STANDARD PRACTICES - ENGINE - INFORMATION - FUEL AND CONTROL - INTRODUCE A NEW FUEL  
DIVERTER AND RETURN VALVE WITH IMPROVED SEALING FEATURES - CATEGORY CODE 7 -  
MOD.ENG-70-0118

V2500-ENG-70-0118

No. 13298-73-001

## ENGINE FUEL CONTROL - INTRODUCTION OF A NEW FUEL DIVERTER AND RETURN VALVE

Valve & Sleeve Matched Set - Before and After Alteration  
Figure 1, Sheet 1 of 2

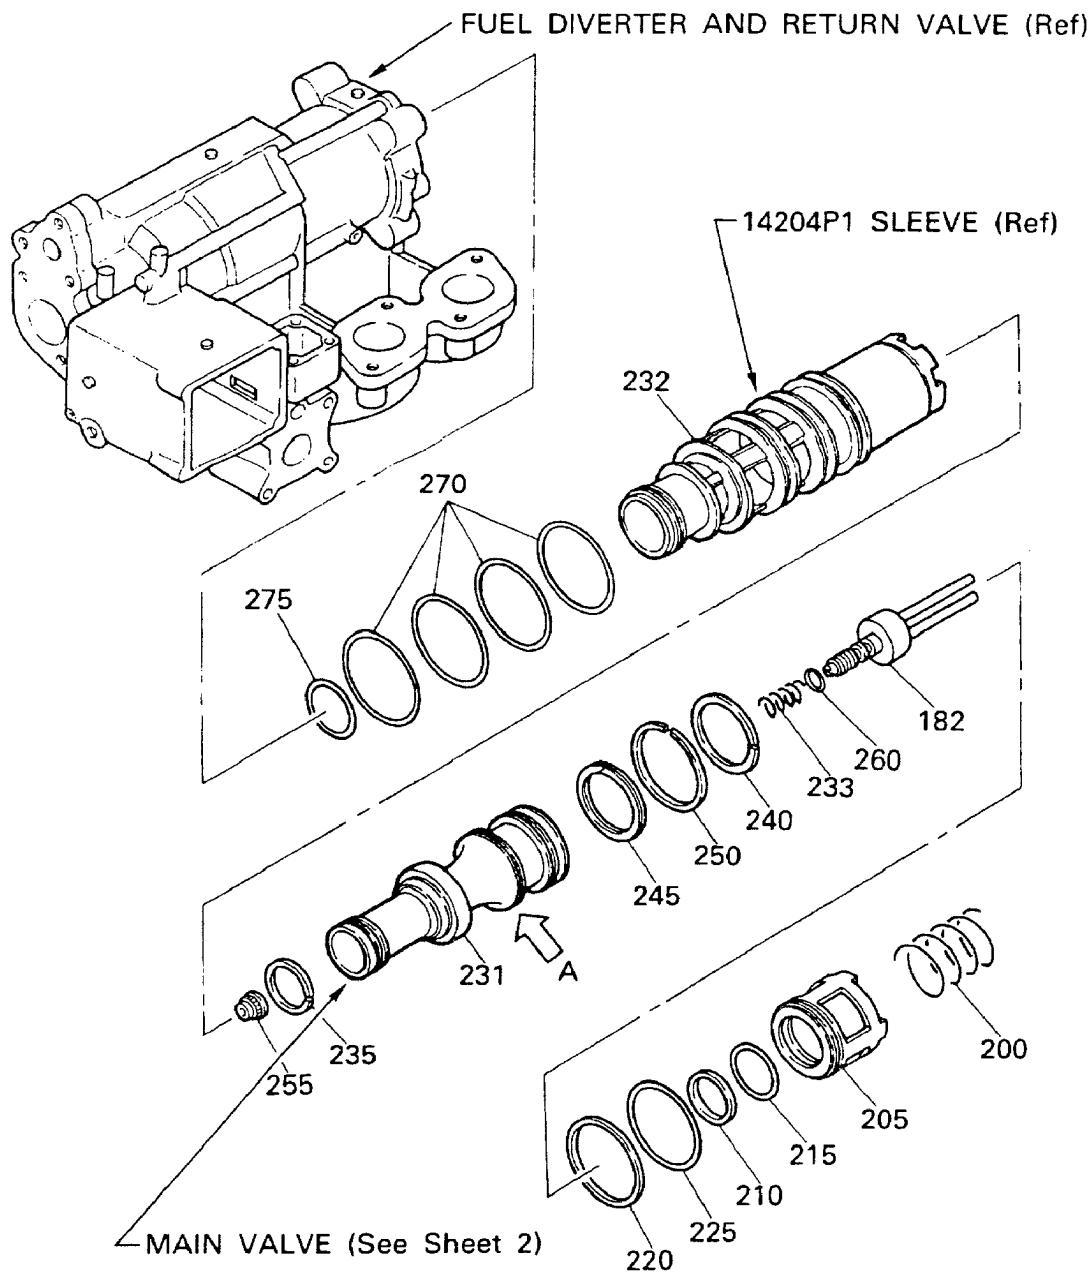
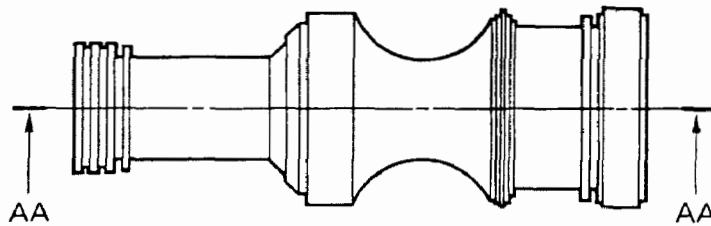
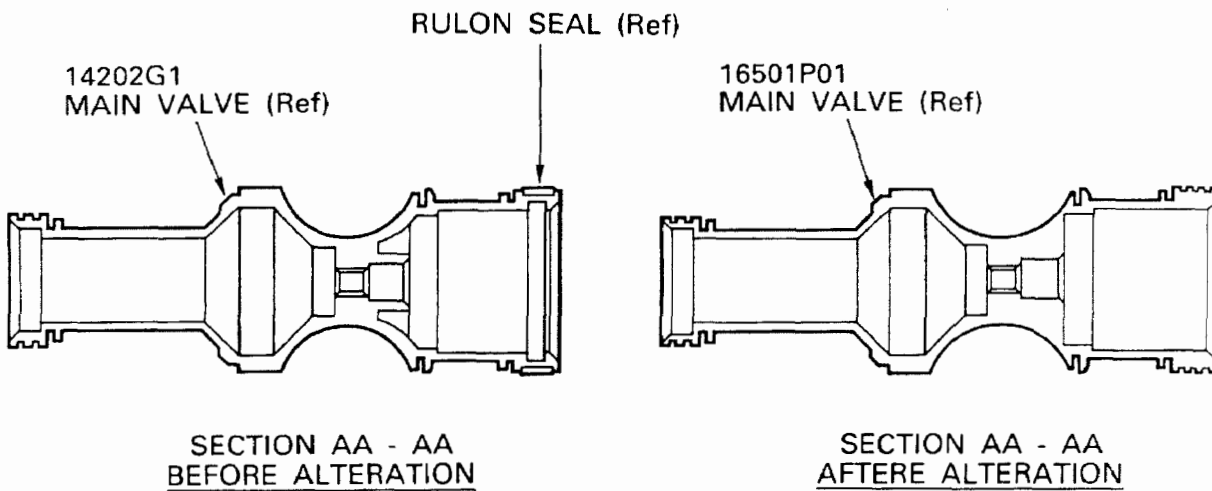
There have been several instances when the Main Valve of the FDRV did not move freely at a high fuel temperature. This has been attributed to the Rulon Seal used on the Valve & Sleeve Matched Set. The seal may interrupt movement of the Main Valve in the Sleeve due to thermal expansion at a high fuel temperature.

An engineering review has shown that the existing valve sealing features are to be changed from the Rulon Seal to the clearance seal to facilitate the clearance control between the Main Valve and the Sleeve.

(a) The sealing features of the Valve & Sleeve Matched Set have been changed from the existing Rulon Seal to the clearance seal.  
(See Figure 1.)

SECTION AA - AA  
BEFORE ALTERATION

SECTION AA - AA  
AFTERE ALTERATION

Replacement of the Valve & Sleeve Matched Set  
Figure 2

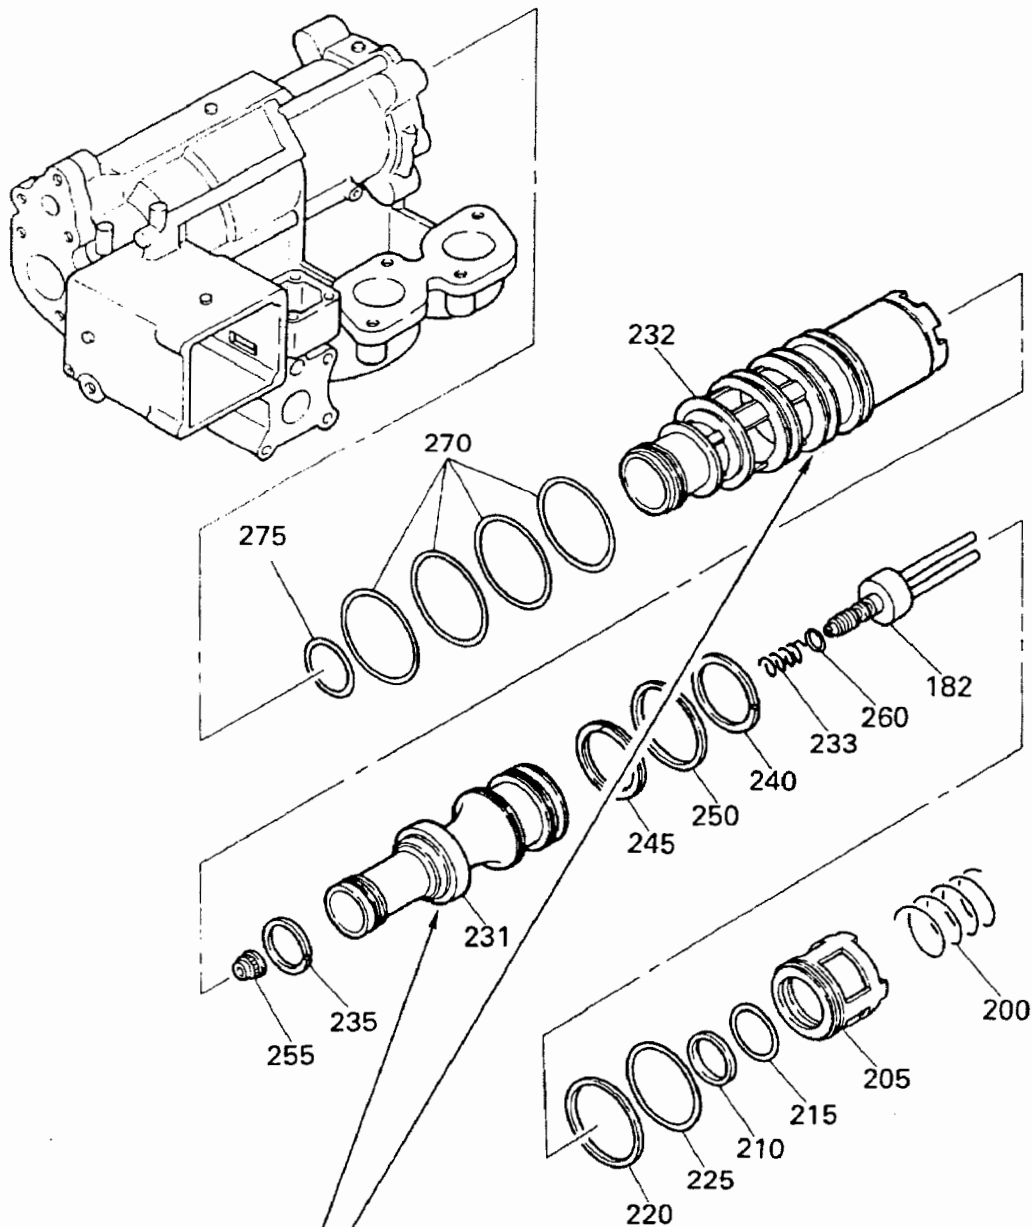
- (b) Replace PN 14201G1, Valve & Sleeve Matched Set, with new PN 16503G01, Valve & Sleeve Matched Set. Discard the old PN 14201G1, Valve & Sleeve Matched Set. (Refer to Figure 2.)

REPLACE THE EXISTING PN 14201G1 VALVE & SLEEVE  
MATCHED SET (1 off) WITH THE NEW PN 16503G01  
VALVE & SLEEVE MATCHED SET (1 off).

Reidentification of the Fuel Diverter and Return Valve  
Figure 3

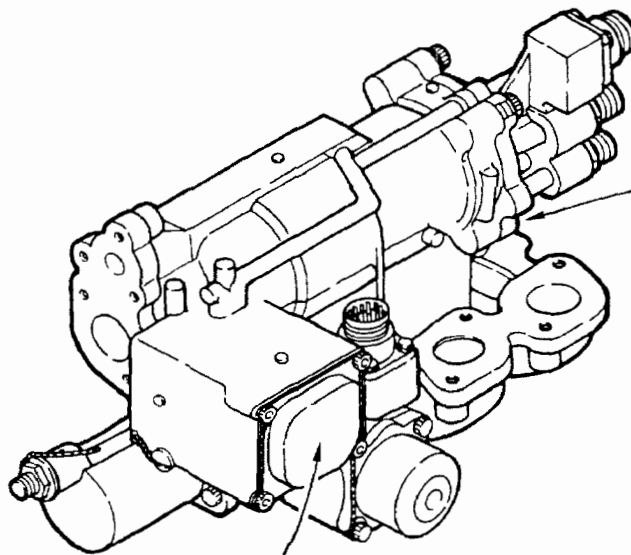
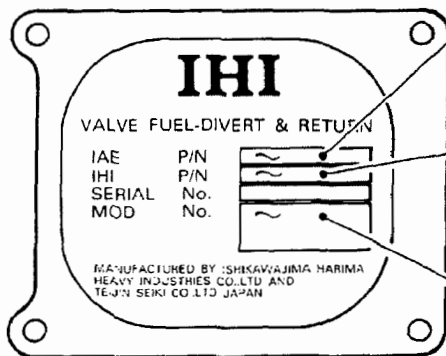
- (d) Reidentify the FDRV with following on the existing name plate with the metal stamps by hand press (Refer to Figure 3.):

MAKE A MARK OF NEW PN 5L0031  
WITH METAL STAMPS BY HAND PRESS  
ADJACENT TO THE EXISTING PN 5L0004.  
MAKE TWO LINES (==) ON EXISTING PN  
TO ERASE IT.

MAKE A MARK OF NEW PN 13298G11  
WITH METAL STAMPS BY HAND PRESS  
ADJACENT TO THE EXISTING PN 13298G10.  
MAKE TWO LINES (==) ON EXISTING PN  
TO ERASE IT.

MAKE A MARK OF NEW MOD. No. BS12  
WITH METAL STAMPS BY HAND PRESS  
ADJACENT TO THE EXISTING MOD. No. BS5  
MAKE TWO LINES (==) ON EXISTING MOD.  
No. TO ERASE IT.
